Plan Commission

Monday, March 25, 2019

SUBJECT: Recommendation regarding a Precise Implementation Plan (PIP) for 428 N. Superior Street (Parcel ED-477). Submitted by Joel Ehrfurth, Mach IV Engineering & Surveying, authorized representative for Irwin School Development LLC, property owner.*

REQUESTED ACTION:	Precise Implementation Plan (PIP) Required follow up to General Plan and Rezoning approvals granted in 2018.
COMMON DESCRIPTION:	428 N. Superior Street, also known as the Irwin School Property.
PARCEL NUMBER:	ED-477
EXISTING ZONING:	R-3 PDD (General Business District with a Planned Development District overlay)
SURROUNDING LAND USES:	R-2 Residential to the north, south, east, and west.
COMPREHENSIVE PLAN:	Commercial

DATE: 03.11.19
SHEET: C1.0

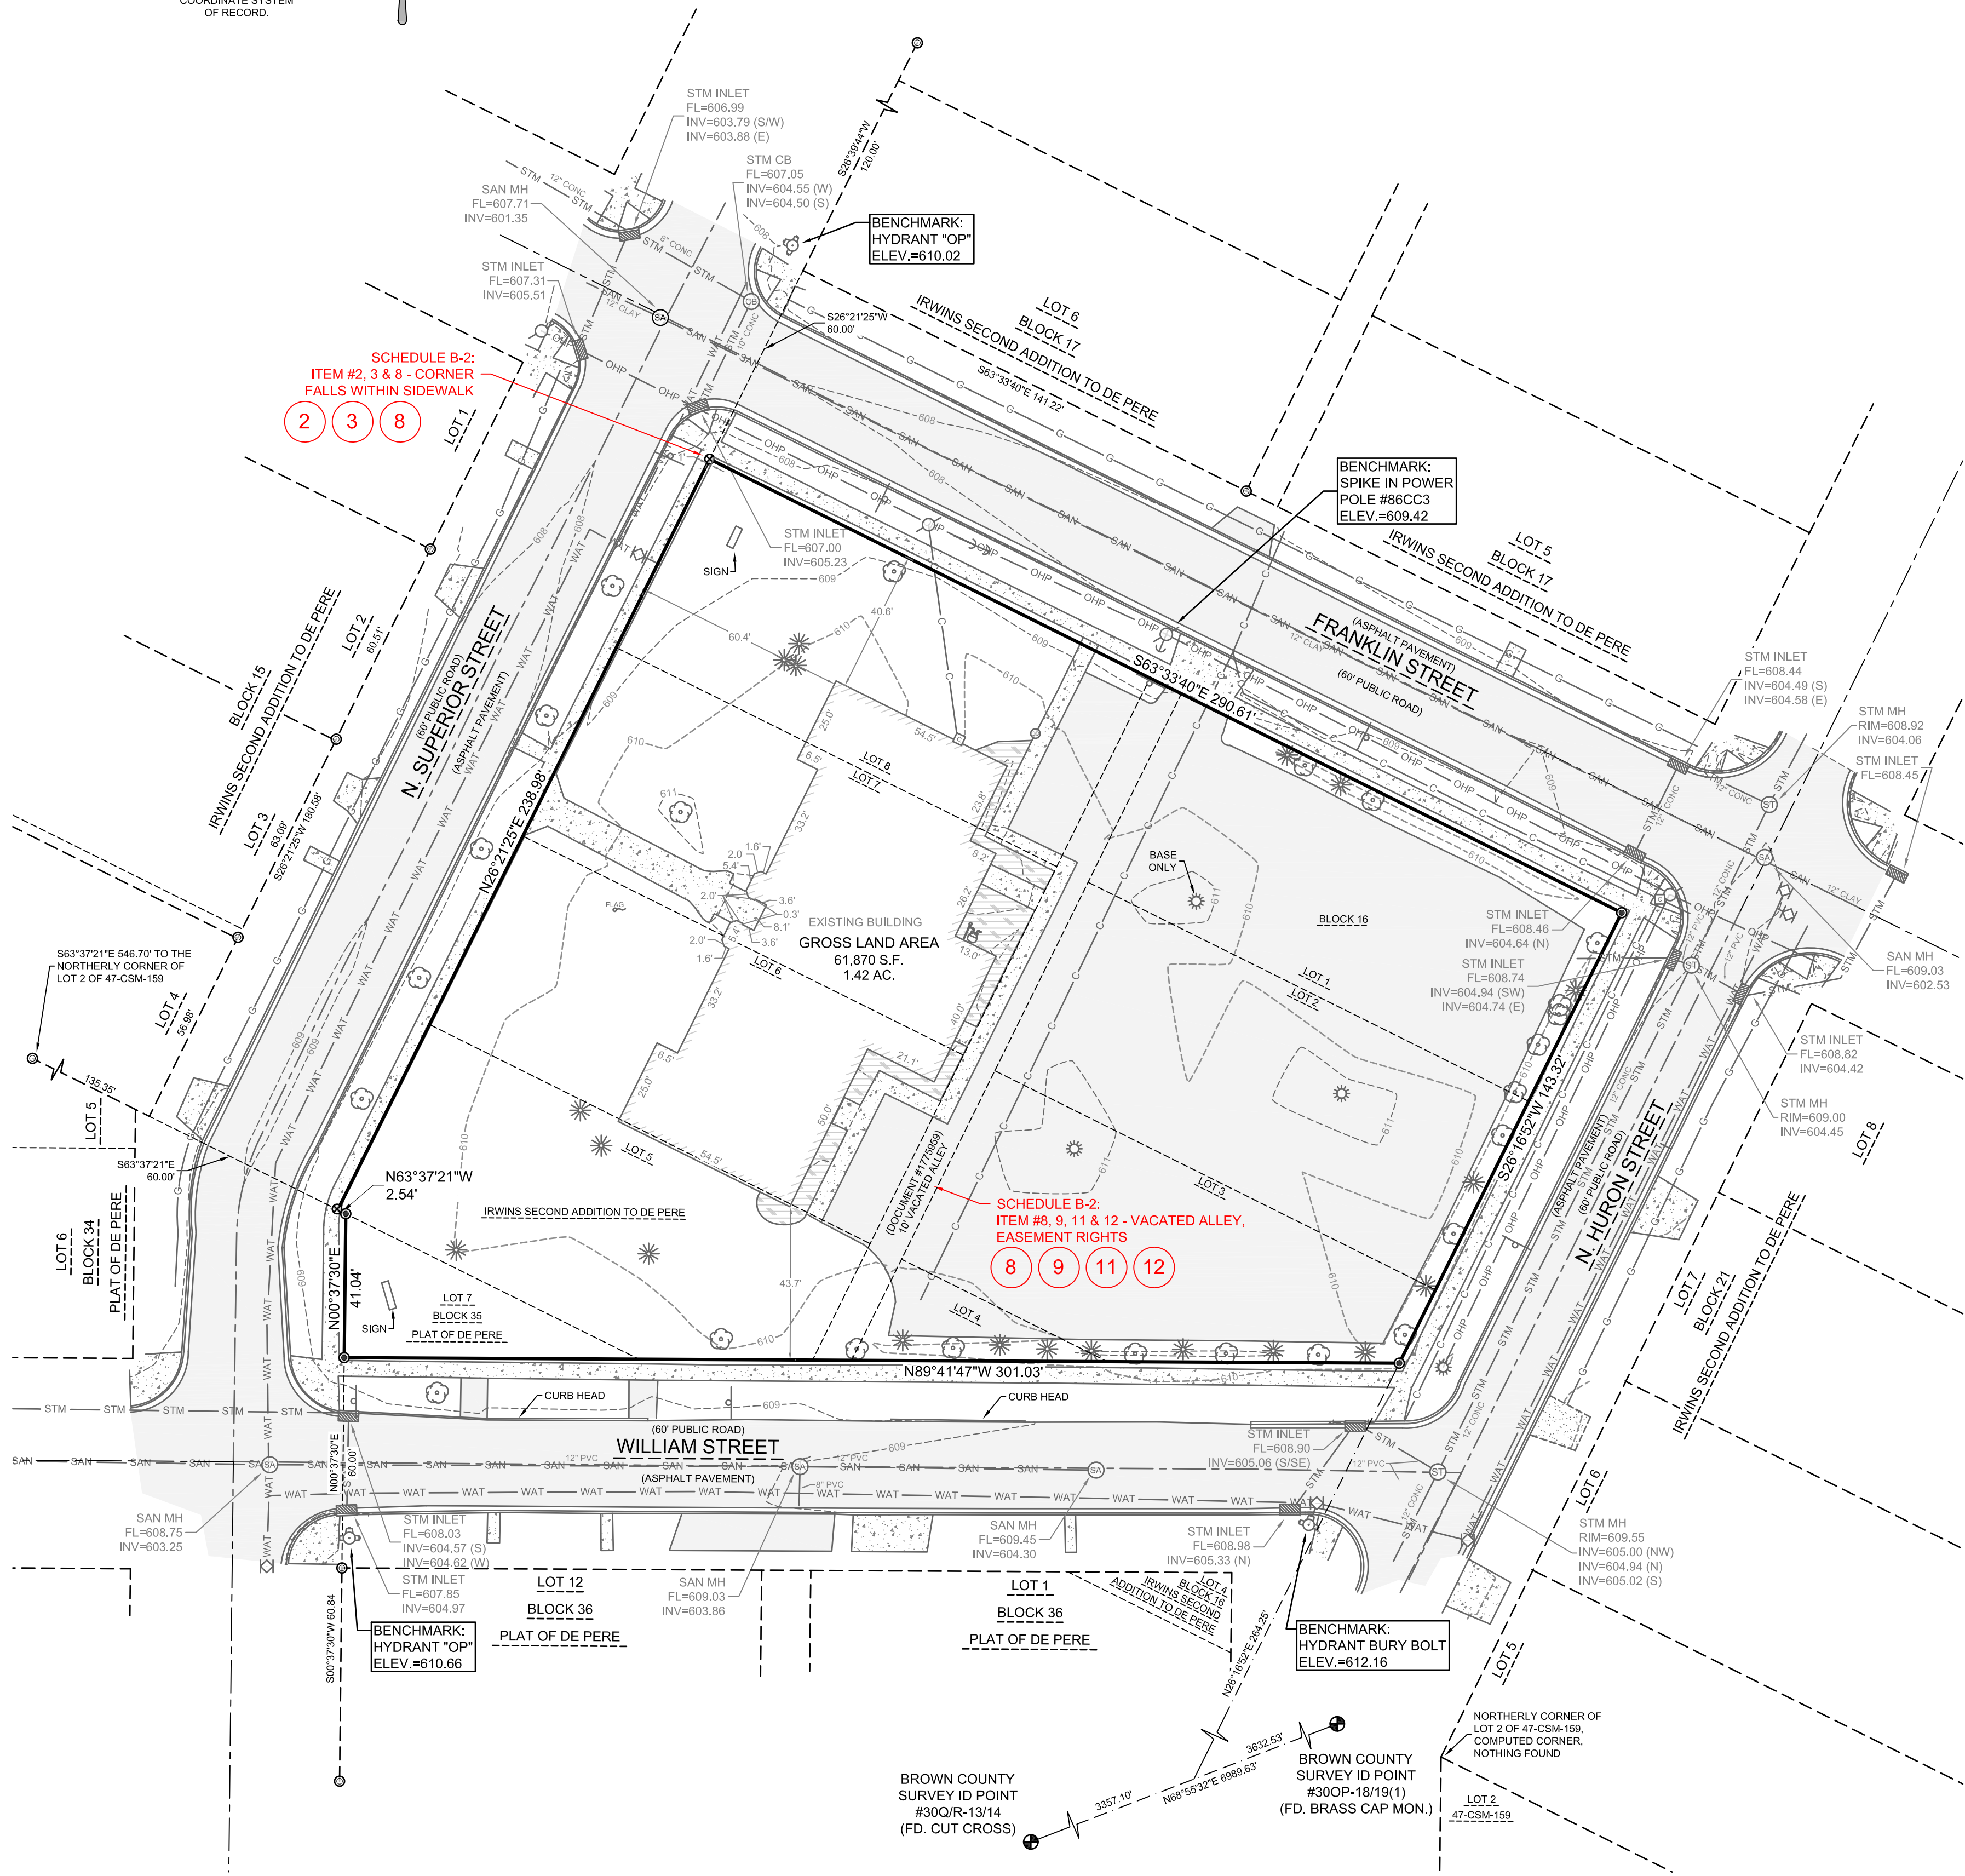
5. Submit a lighting plan to confirm that light spillover into surrounding residential area will not occur.
6. Sheet C1.0 - Need to show sidewalk, driveway, and asphalt pavement removals required for sanitary sewer lateral.

7. Sheet C1.0 - Existing water service and sanitary sewer lateral needs to be abandoned at the main.
8. Sheet C2.0 - Move owner information to sheet C0.1.

DATE: 03.11.19
SHEET: C3.0

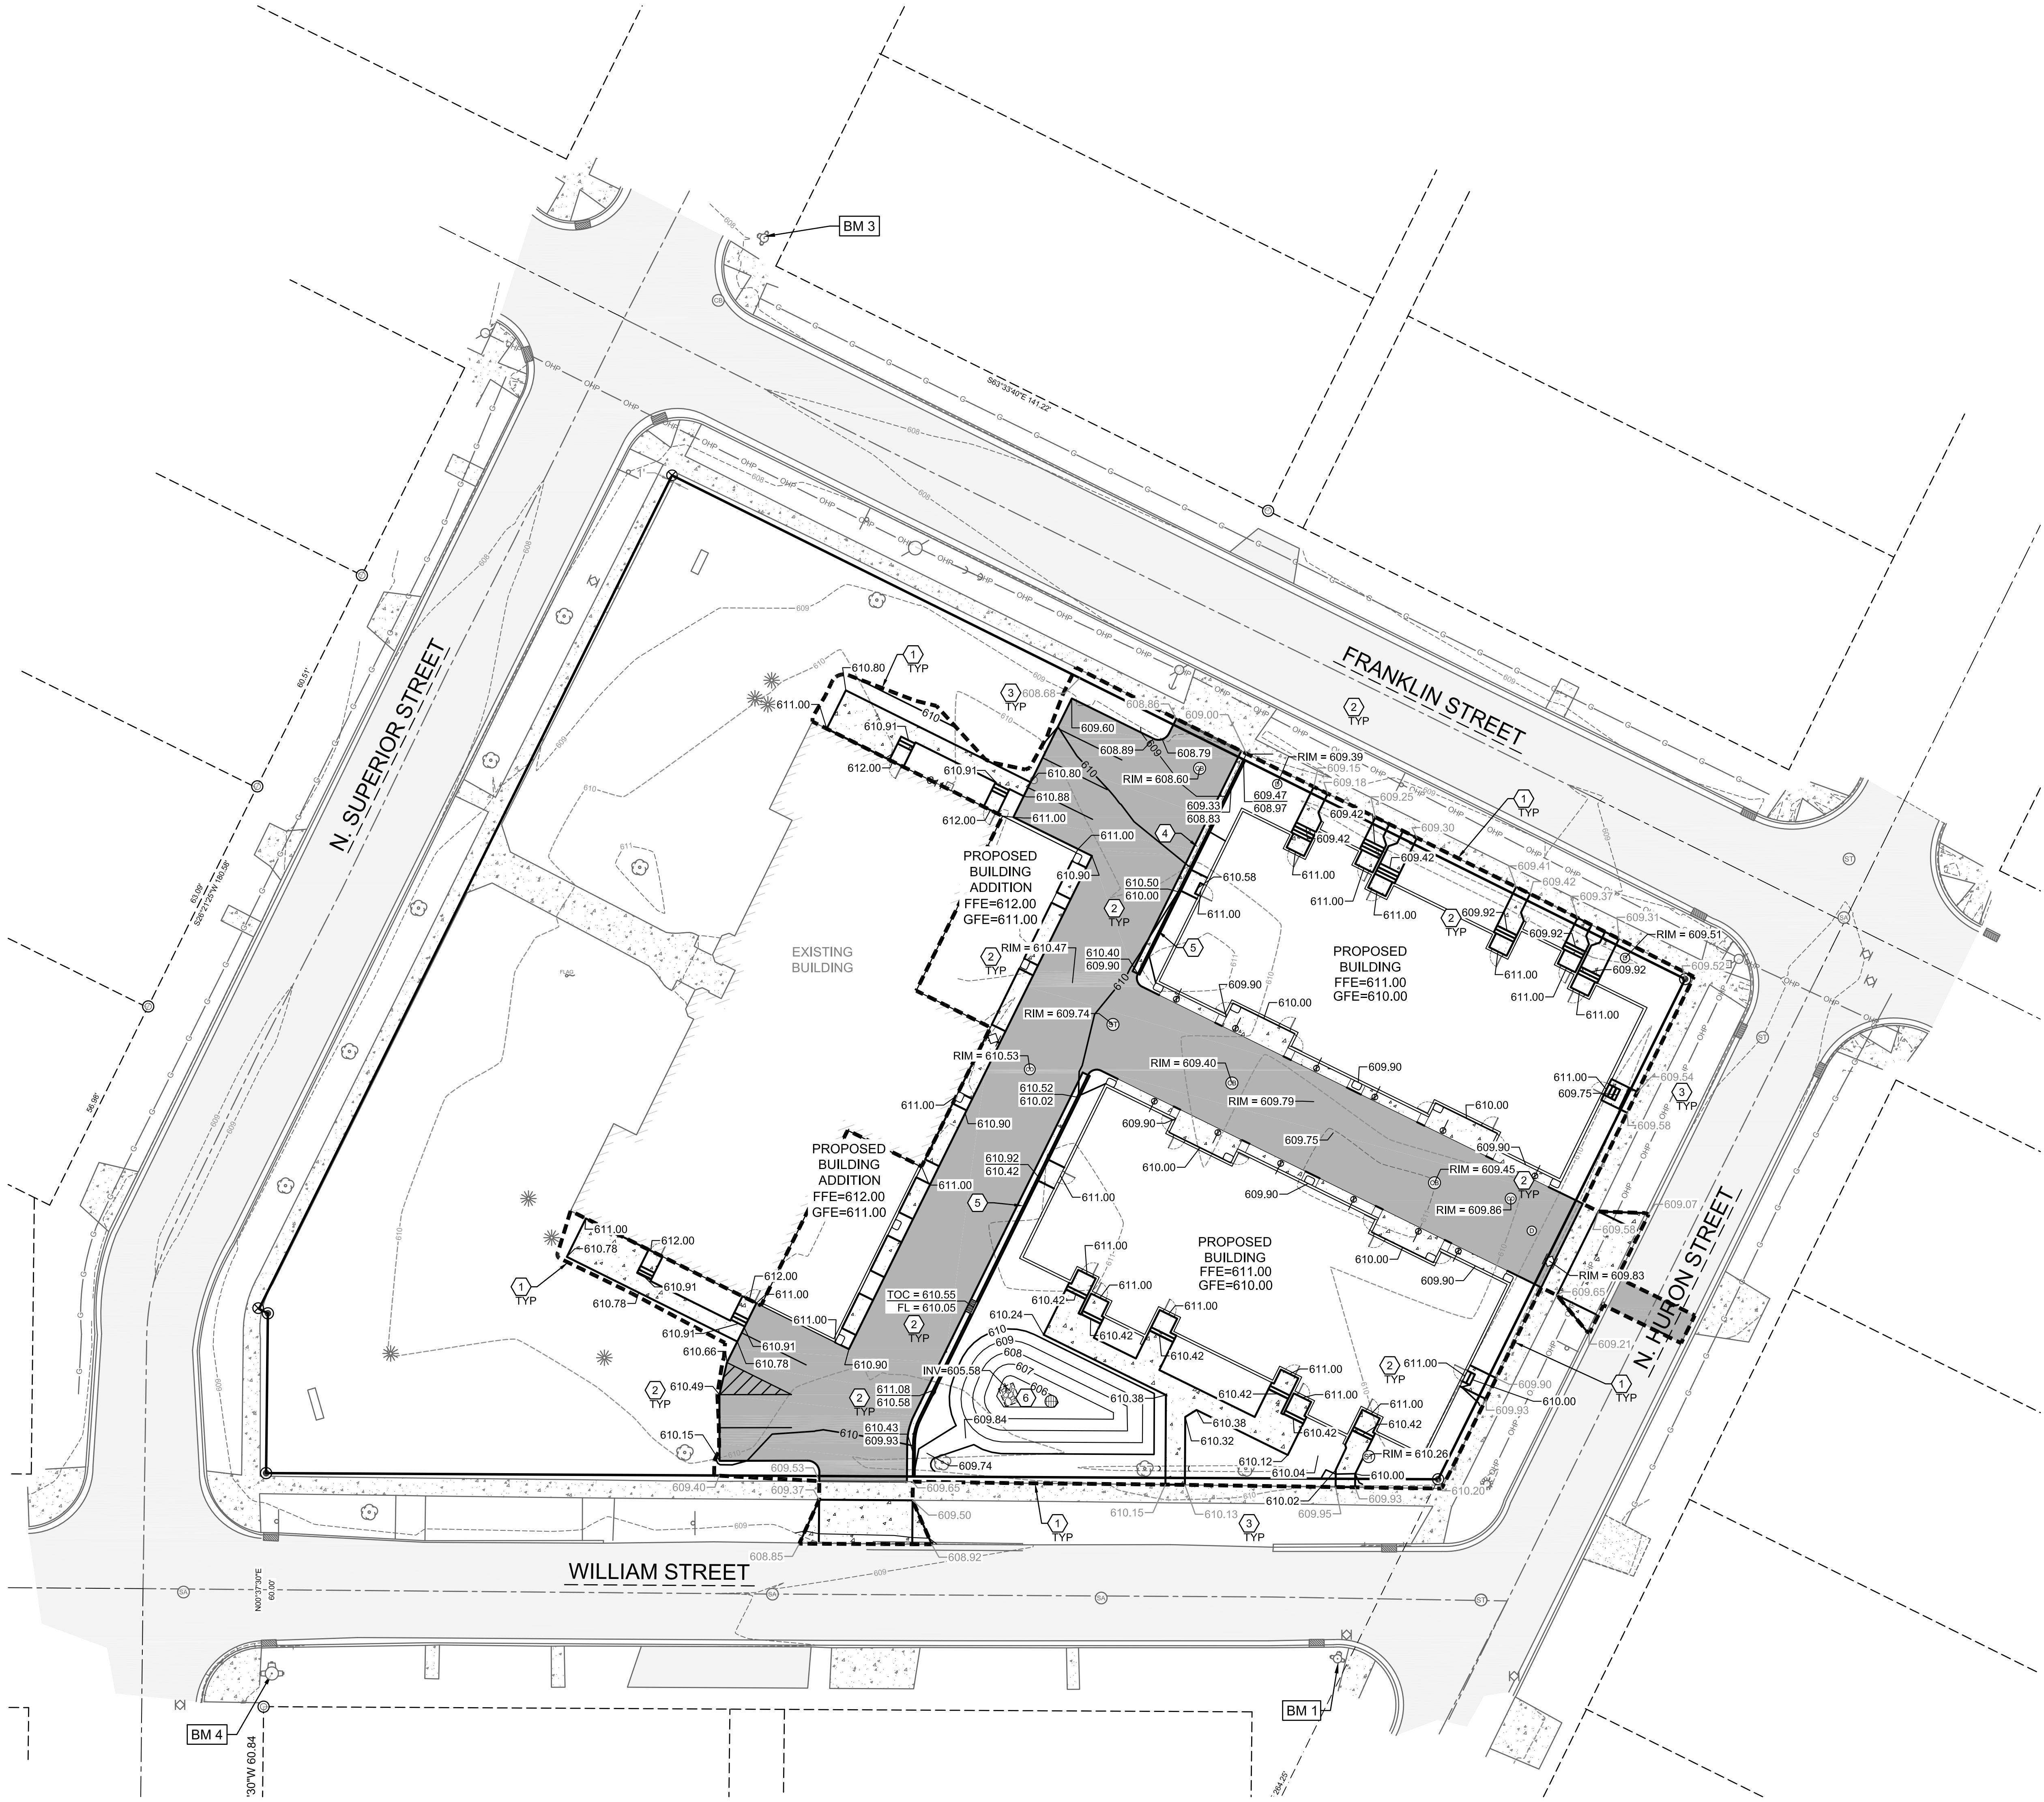
9. Sheet C3.0 - Add comment that the contractor will need an excavation permit for all work in the right-of-way. Please contact De Pere Public Works 920-339-4061 for permit package. Permit review may take up to two weeks.

10. Sheet C3.0 - What size water meter is required. If greater than 1-inch notify water department staff ASAP at 920-339-4063 as the meter will need to be ordered.

11. Sheet C3.0 - If water service is to remain 4-inches in diameter or larger, add the following comment: Prior to going live, the water service will need to be tested (e.g. safe sample and pressure tested).

12. Sheet C3.0 - Add comment to call Engineering staff at 920-339-4061 at least 24-hours in advance to making water service, storm sewer lateral, or sanitary sewer lateral connections so their locations can be documented for city records.

13. Sheet C3.0 - Need to have full width pavement restoration shown for sewer lateral on Franklin Street.
14. Sheet C3.0 - Sanitary sewer pipe between San MH20 and proposed invert in the sanitary sewer main on Franklin Street has a slope of 0.84% not 0.60%.

15. Sheet C3.0 - Storm Sewer pipe between STM CO10 and STM CO9 has a slope of 1.20% not 1.07%
16. Sheet C3.0 - Pipe between dry pond outlet structure and STM Manhole 1 has a slope of 0.53% not 0.41%.

17. Sheet C3.0 - Additional comments will be provided as the water system will need to be reviewed again to fix metering comment listed above.
18. Sheet C3.0 - Need to see sidewalk replacement limits for both storm sewer
